APPLICATION NO.	FILING DATE	FIRST NAMED INVENTOR	ATTORNEY DOCKET NO.	CONFIRMATION NO.
10/664,557	09/19/2003	Kevin McMains	LGPL.104360	4596
7590 SCOTT B. STROHM, SHOOK, HARDY & BACON L.L.P One Kansas City Place 1200 Main Street Kansas City, MO 64105-2118			EXAMINER LE, TAN	
			ART UNIT 3632	PAPER NUMBER
SHORTENED STATUTORY PERIOD OF RESPONSE			MAIL DATE	DELIVERY MODE
3 MONTHS			03/08/2007	PAPER

Office Action Summary	Application No. 10/664,557	Applicant(s) MCMAINS, KEVIN	
	Examiner Tan Le	Art Unit 3632

DETAILED ACTION

Fig. 4

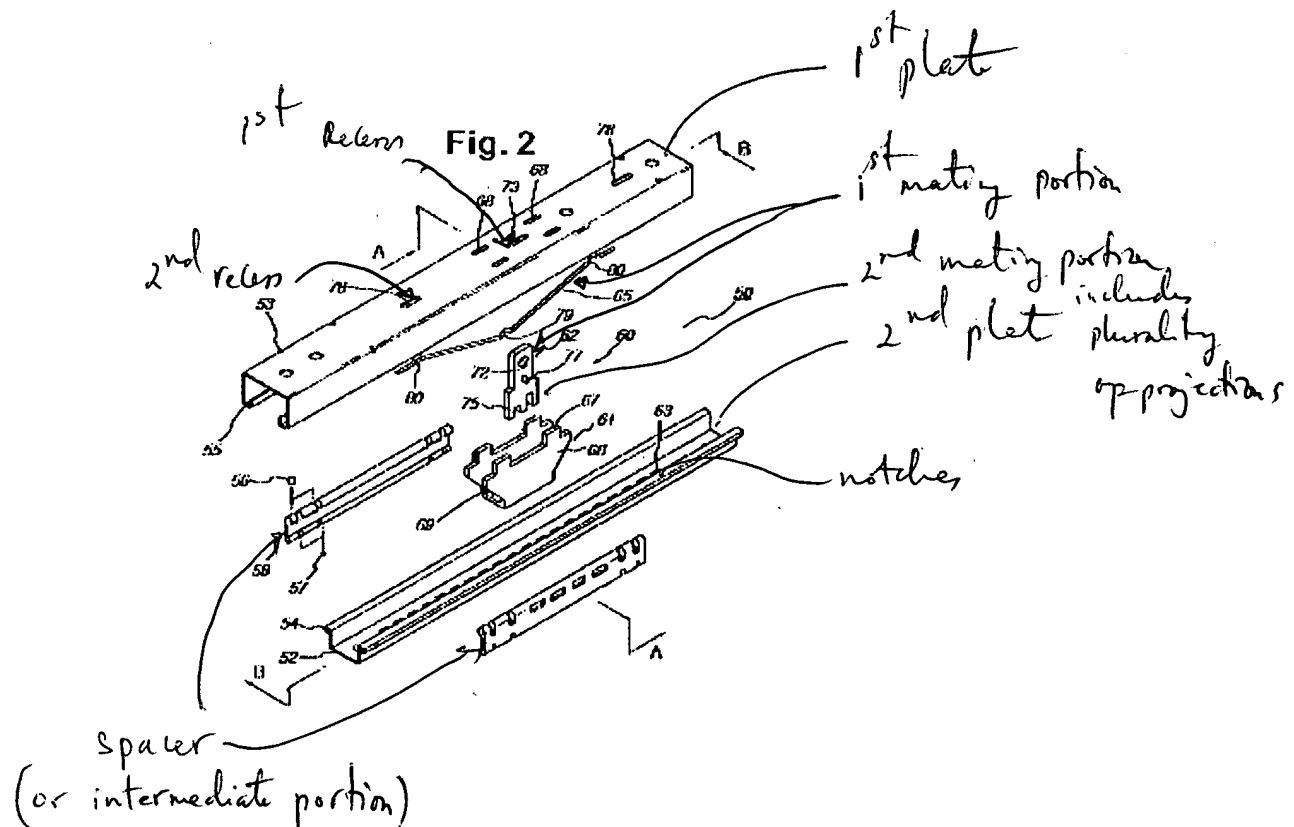
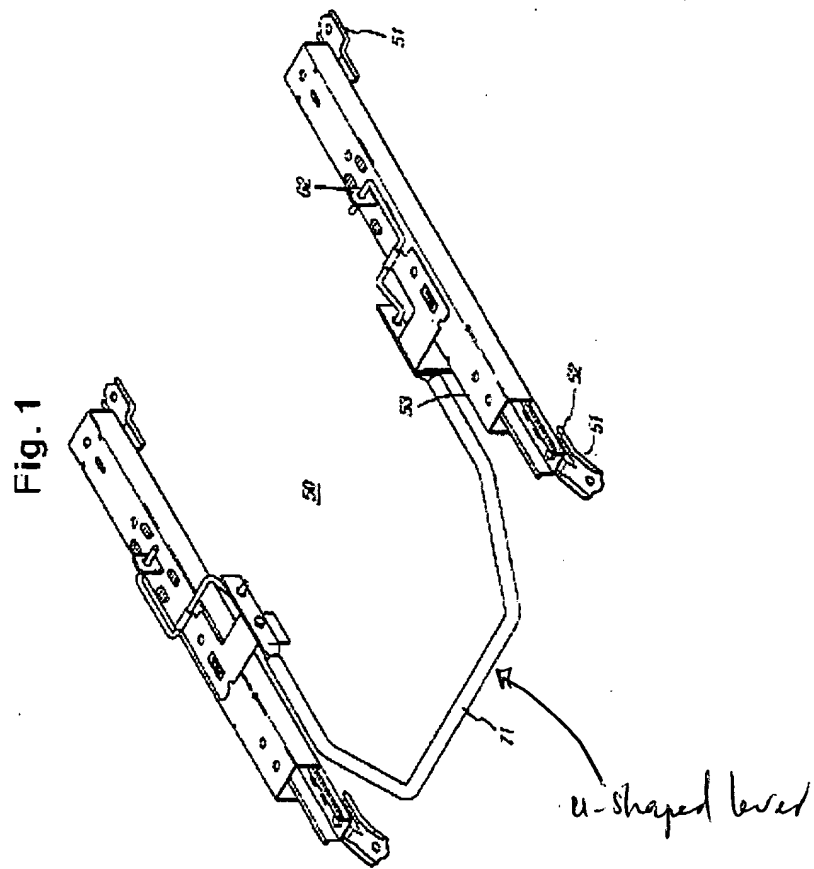
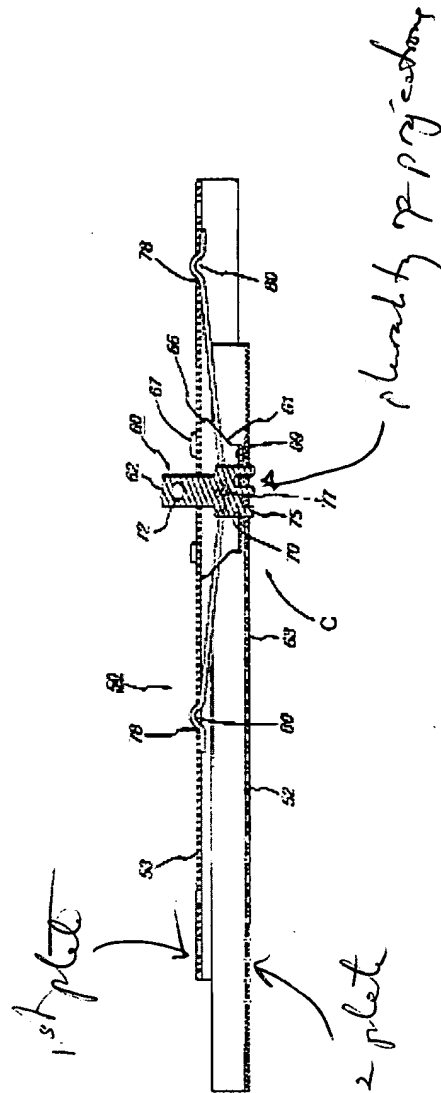
Claims 21 and 23 read on Lee as follows: Lee discloses an adjustment mechanism (Figs. 1-5) comprising: a first plate (53) (see attached figure) adapted to be coupled to a bottom surface of the seat; a second plate (52) adapted to be coupled to an upper surface of the tilt control mechanism, said second plate being slidably coupled to said first plate such that said first and second plates can move relative to one another along the longitudinal axis of the seat; a spacer (58) (also col. 3, lines 61-65), said spacer positioned between said first and second plates for facilitating relative sliding movement therebetween, wherein said first and second plates cooperate to provide a means for selectively adjusting the seat along the longitudinal axis thereof; and a U-shaped lever (71), said U-shaped lever containing a first mating portion (62) adapted to be releasably received in a recess (73) located in the first plate and a second mating portion (75) including a projection adapted to be releasably received in a plurality of notches (63) located on the second plate wherein said U-shaped lever is operable to selectively engage the second mating portion and a selected one of said notches and is operable to selectively release the second mating portion from the selected one of said notches to allow the first plate to move relative to the second plate.

As to claim 34, wherein the mating portion includes first (62) and second mating portions (65, 79, 80), the first and second mating portions adapted to be releasably received in the first (73) and second recesses (78).

As to claim 35, Lee discloses the first (68) and second recess (78) generally rectangular in shape but with round ends. Applicants however, has not discloses that having the recesses with rectangular in shape solves any particular problem or is for any particular purpose. Moreover, it appears that the recesses having rectangular with round ends would perform equally well with the recesses having exactly rectangular without round ends in shape. Accordingly, the use of rectangular in shape is deemed to be a design consideration, which fails to patentably distinguish over the prior art of Lee.

As to claim 37, wherein the mating projection includes first and second mating projections (see attached figure), the projections being adapted to be releasably received in the first and second set of notches.
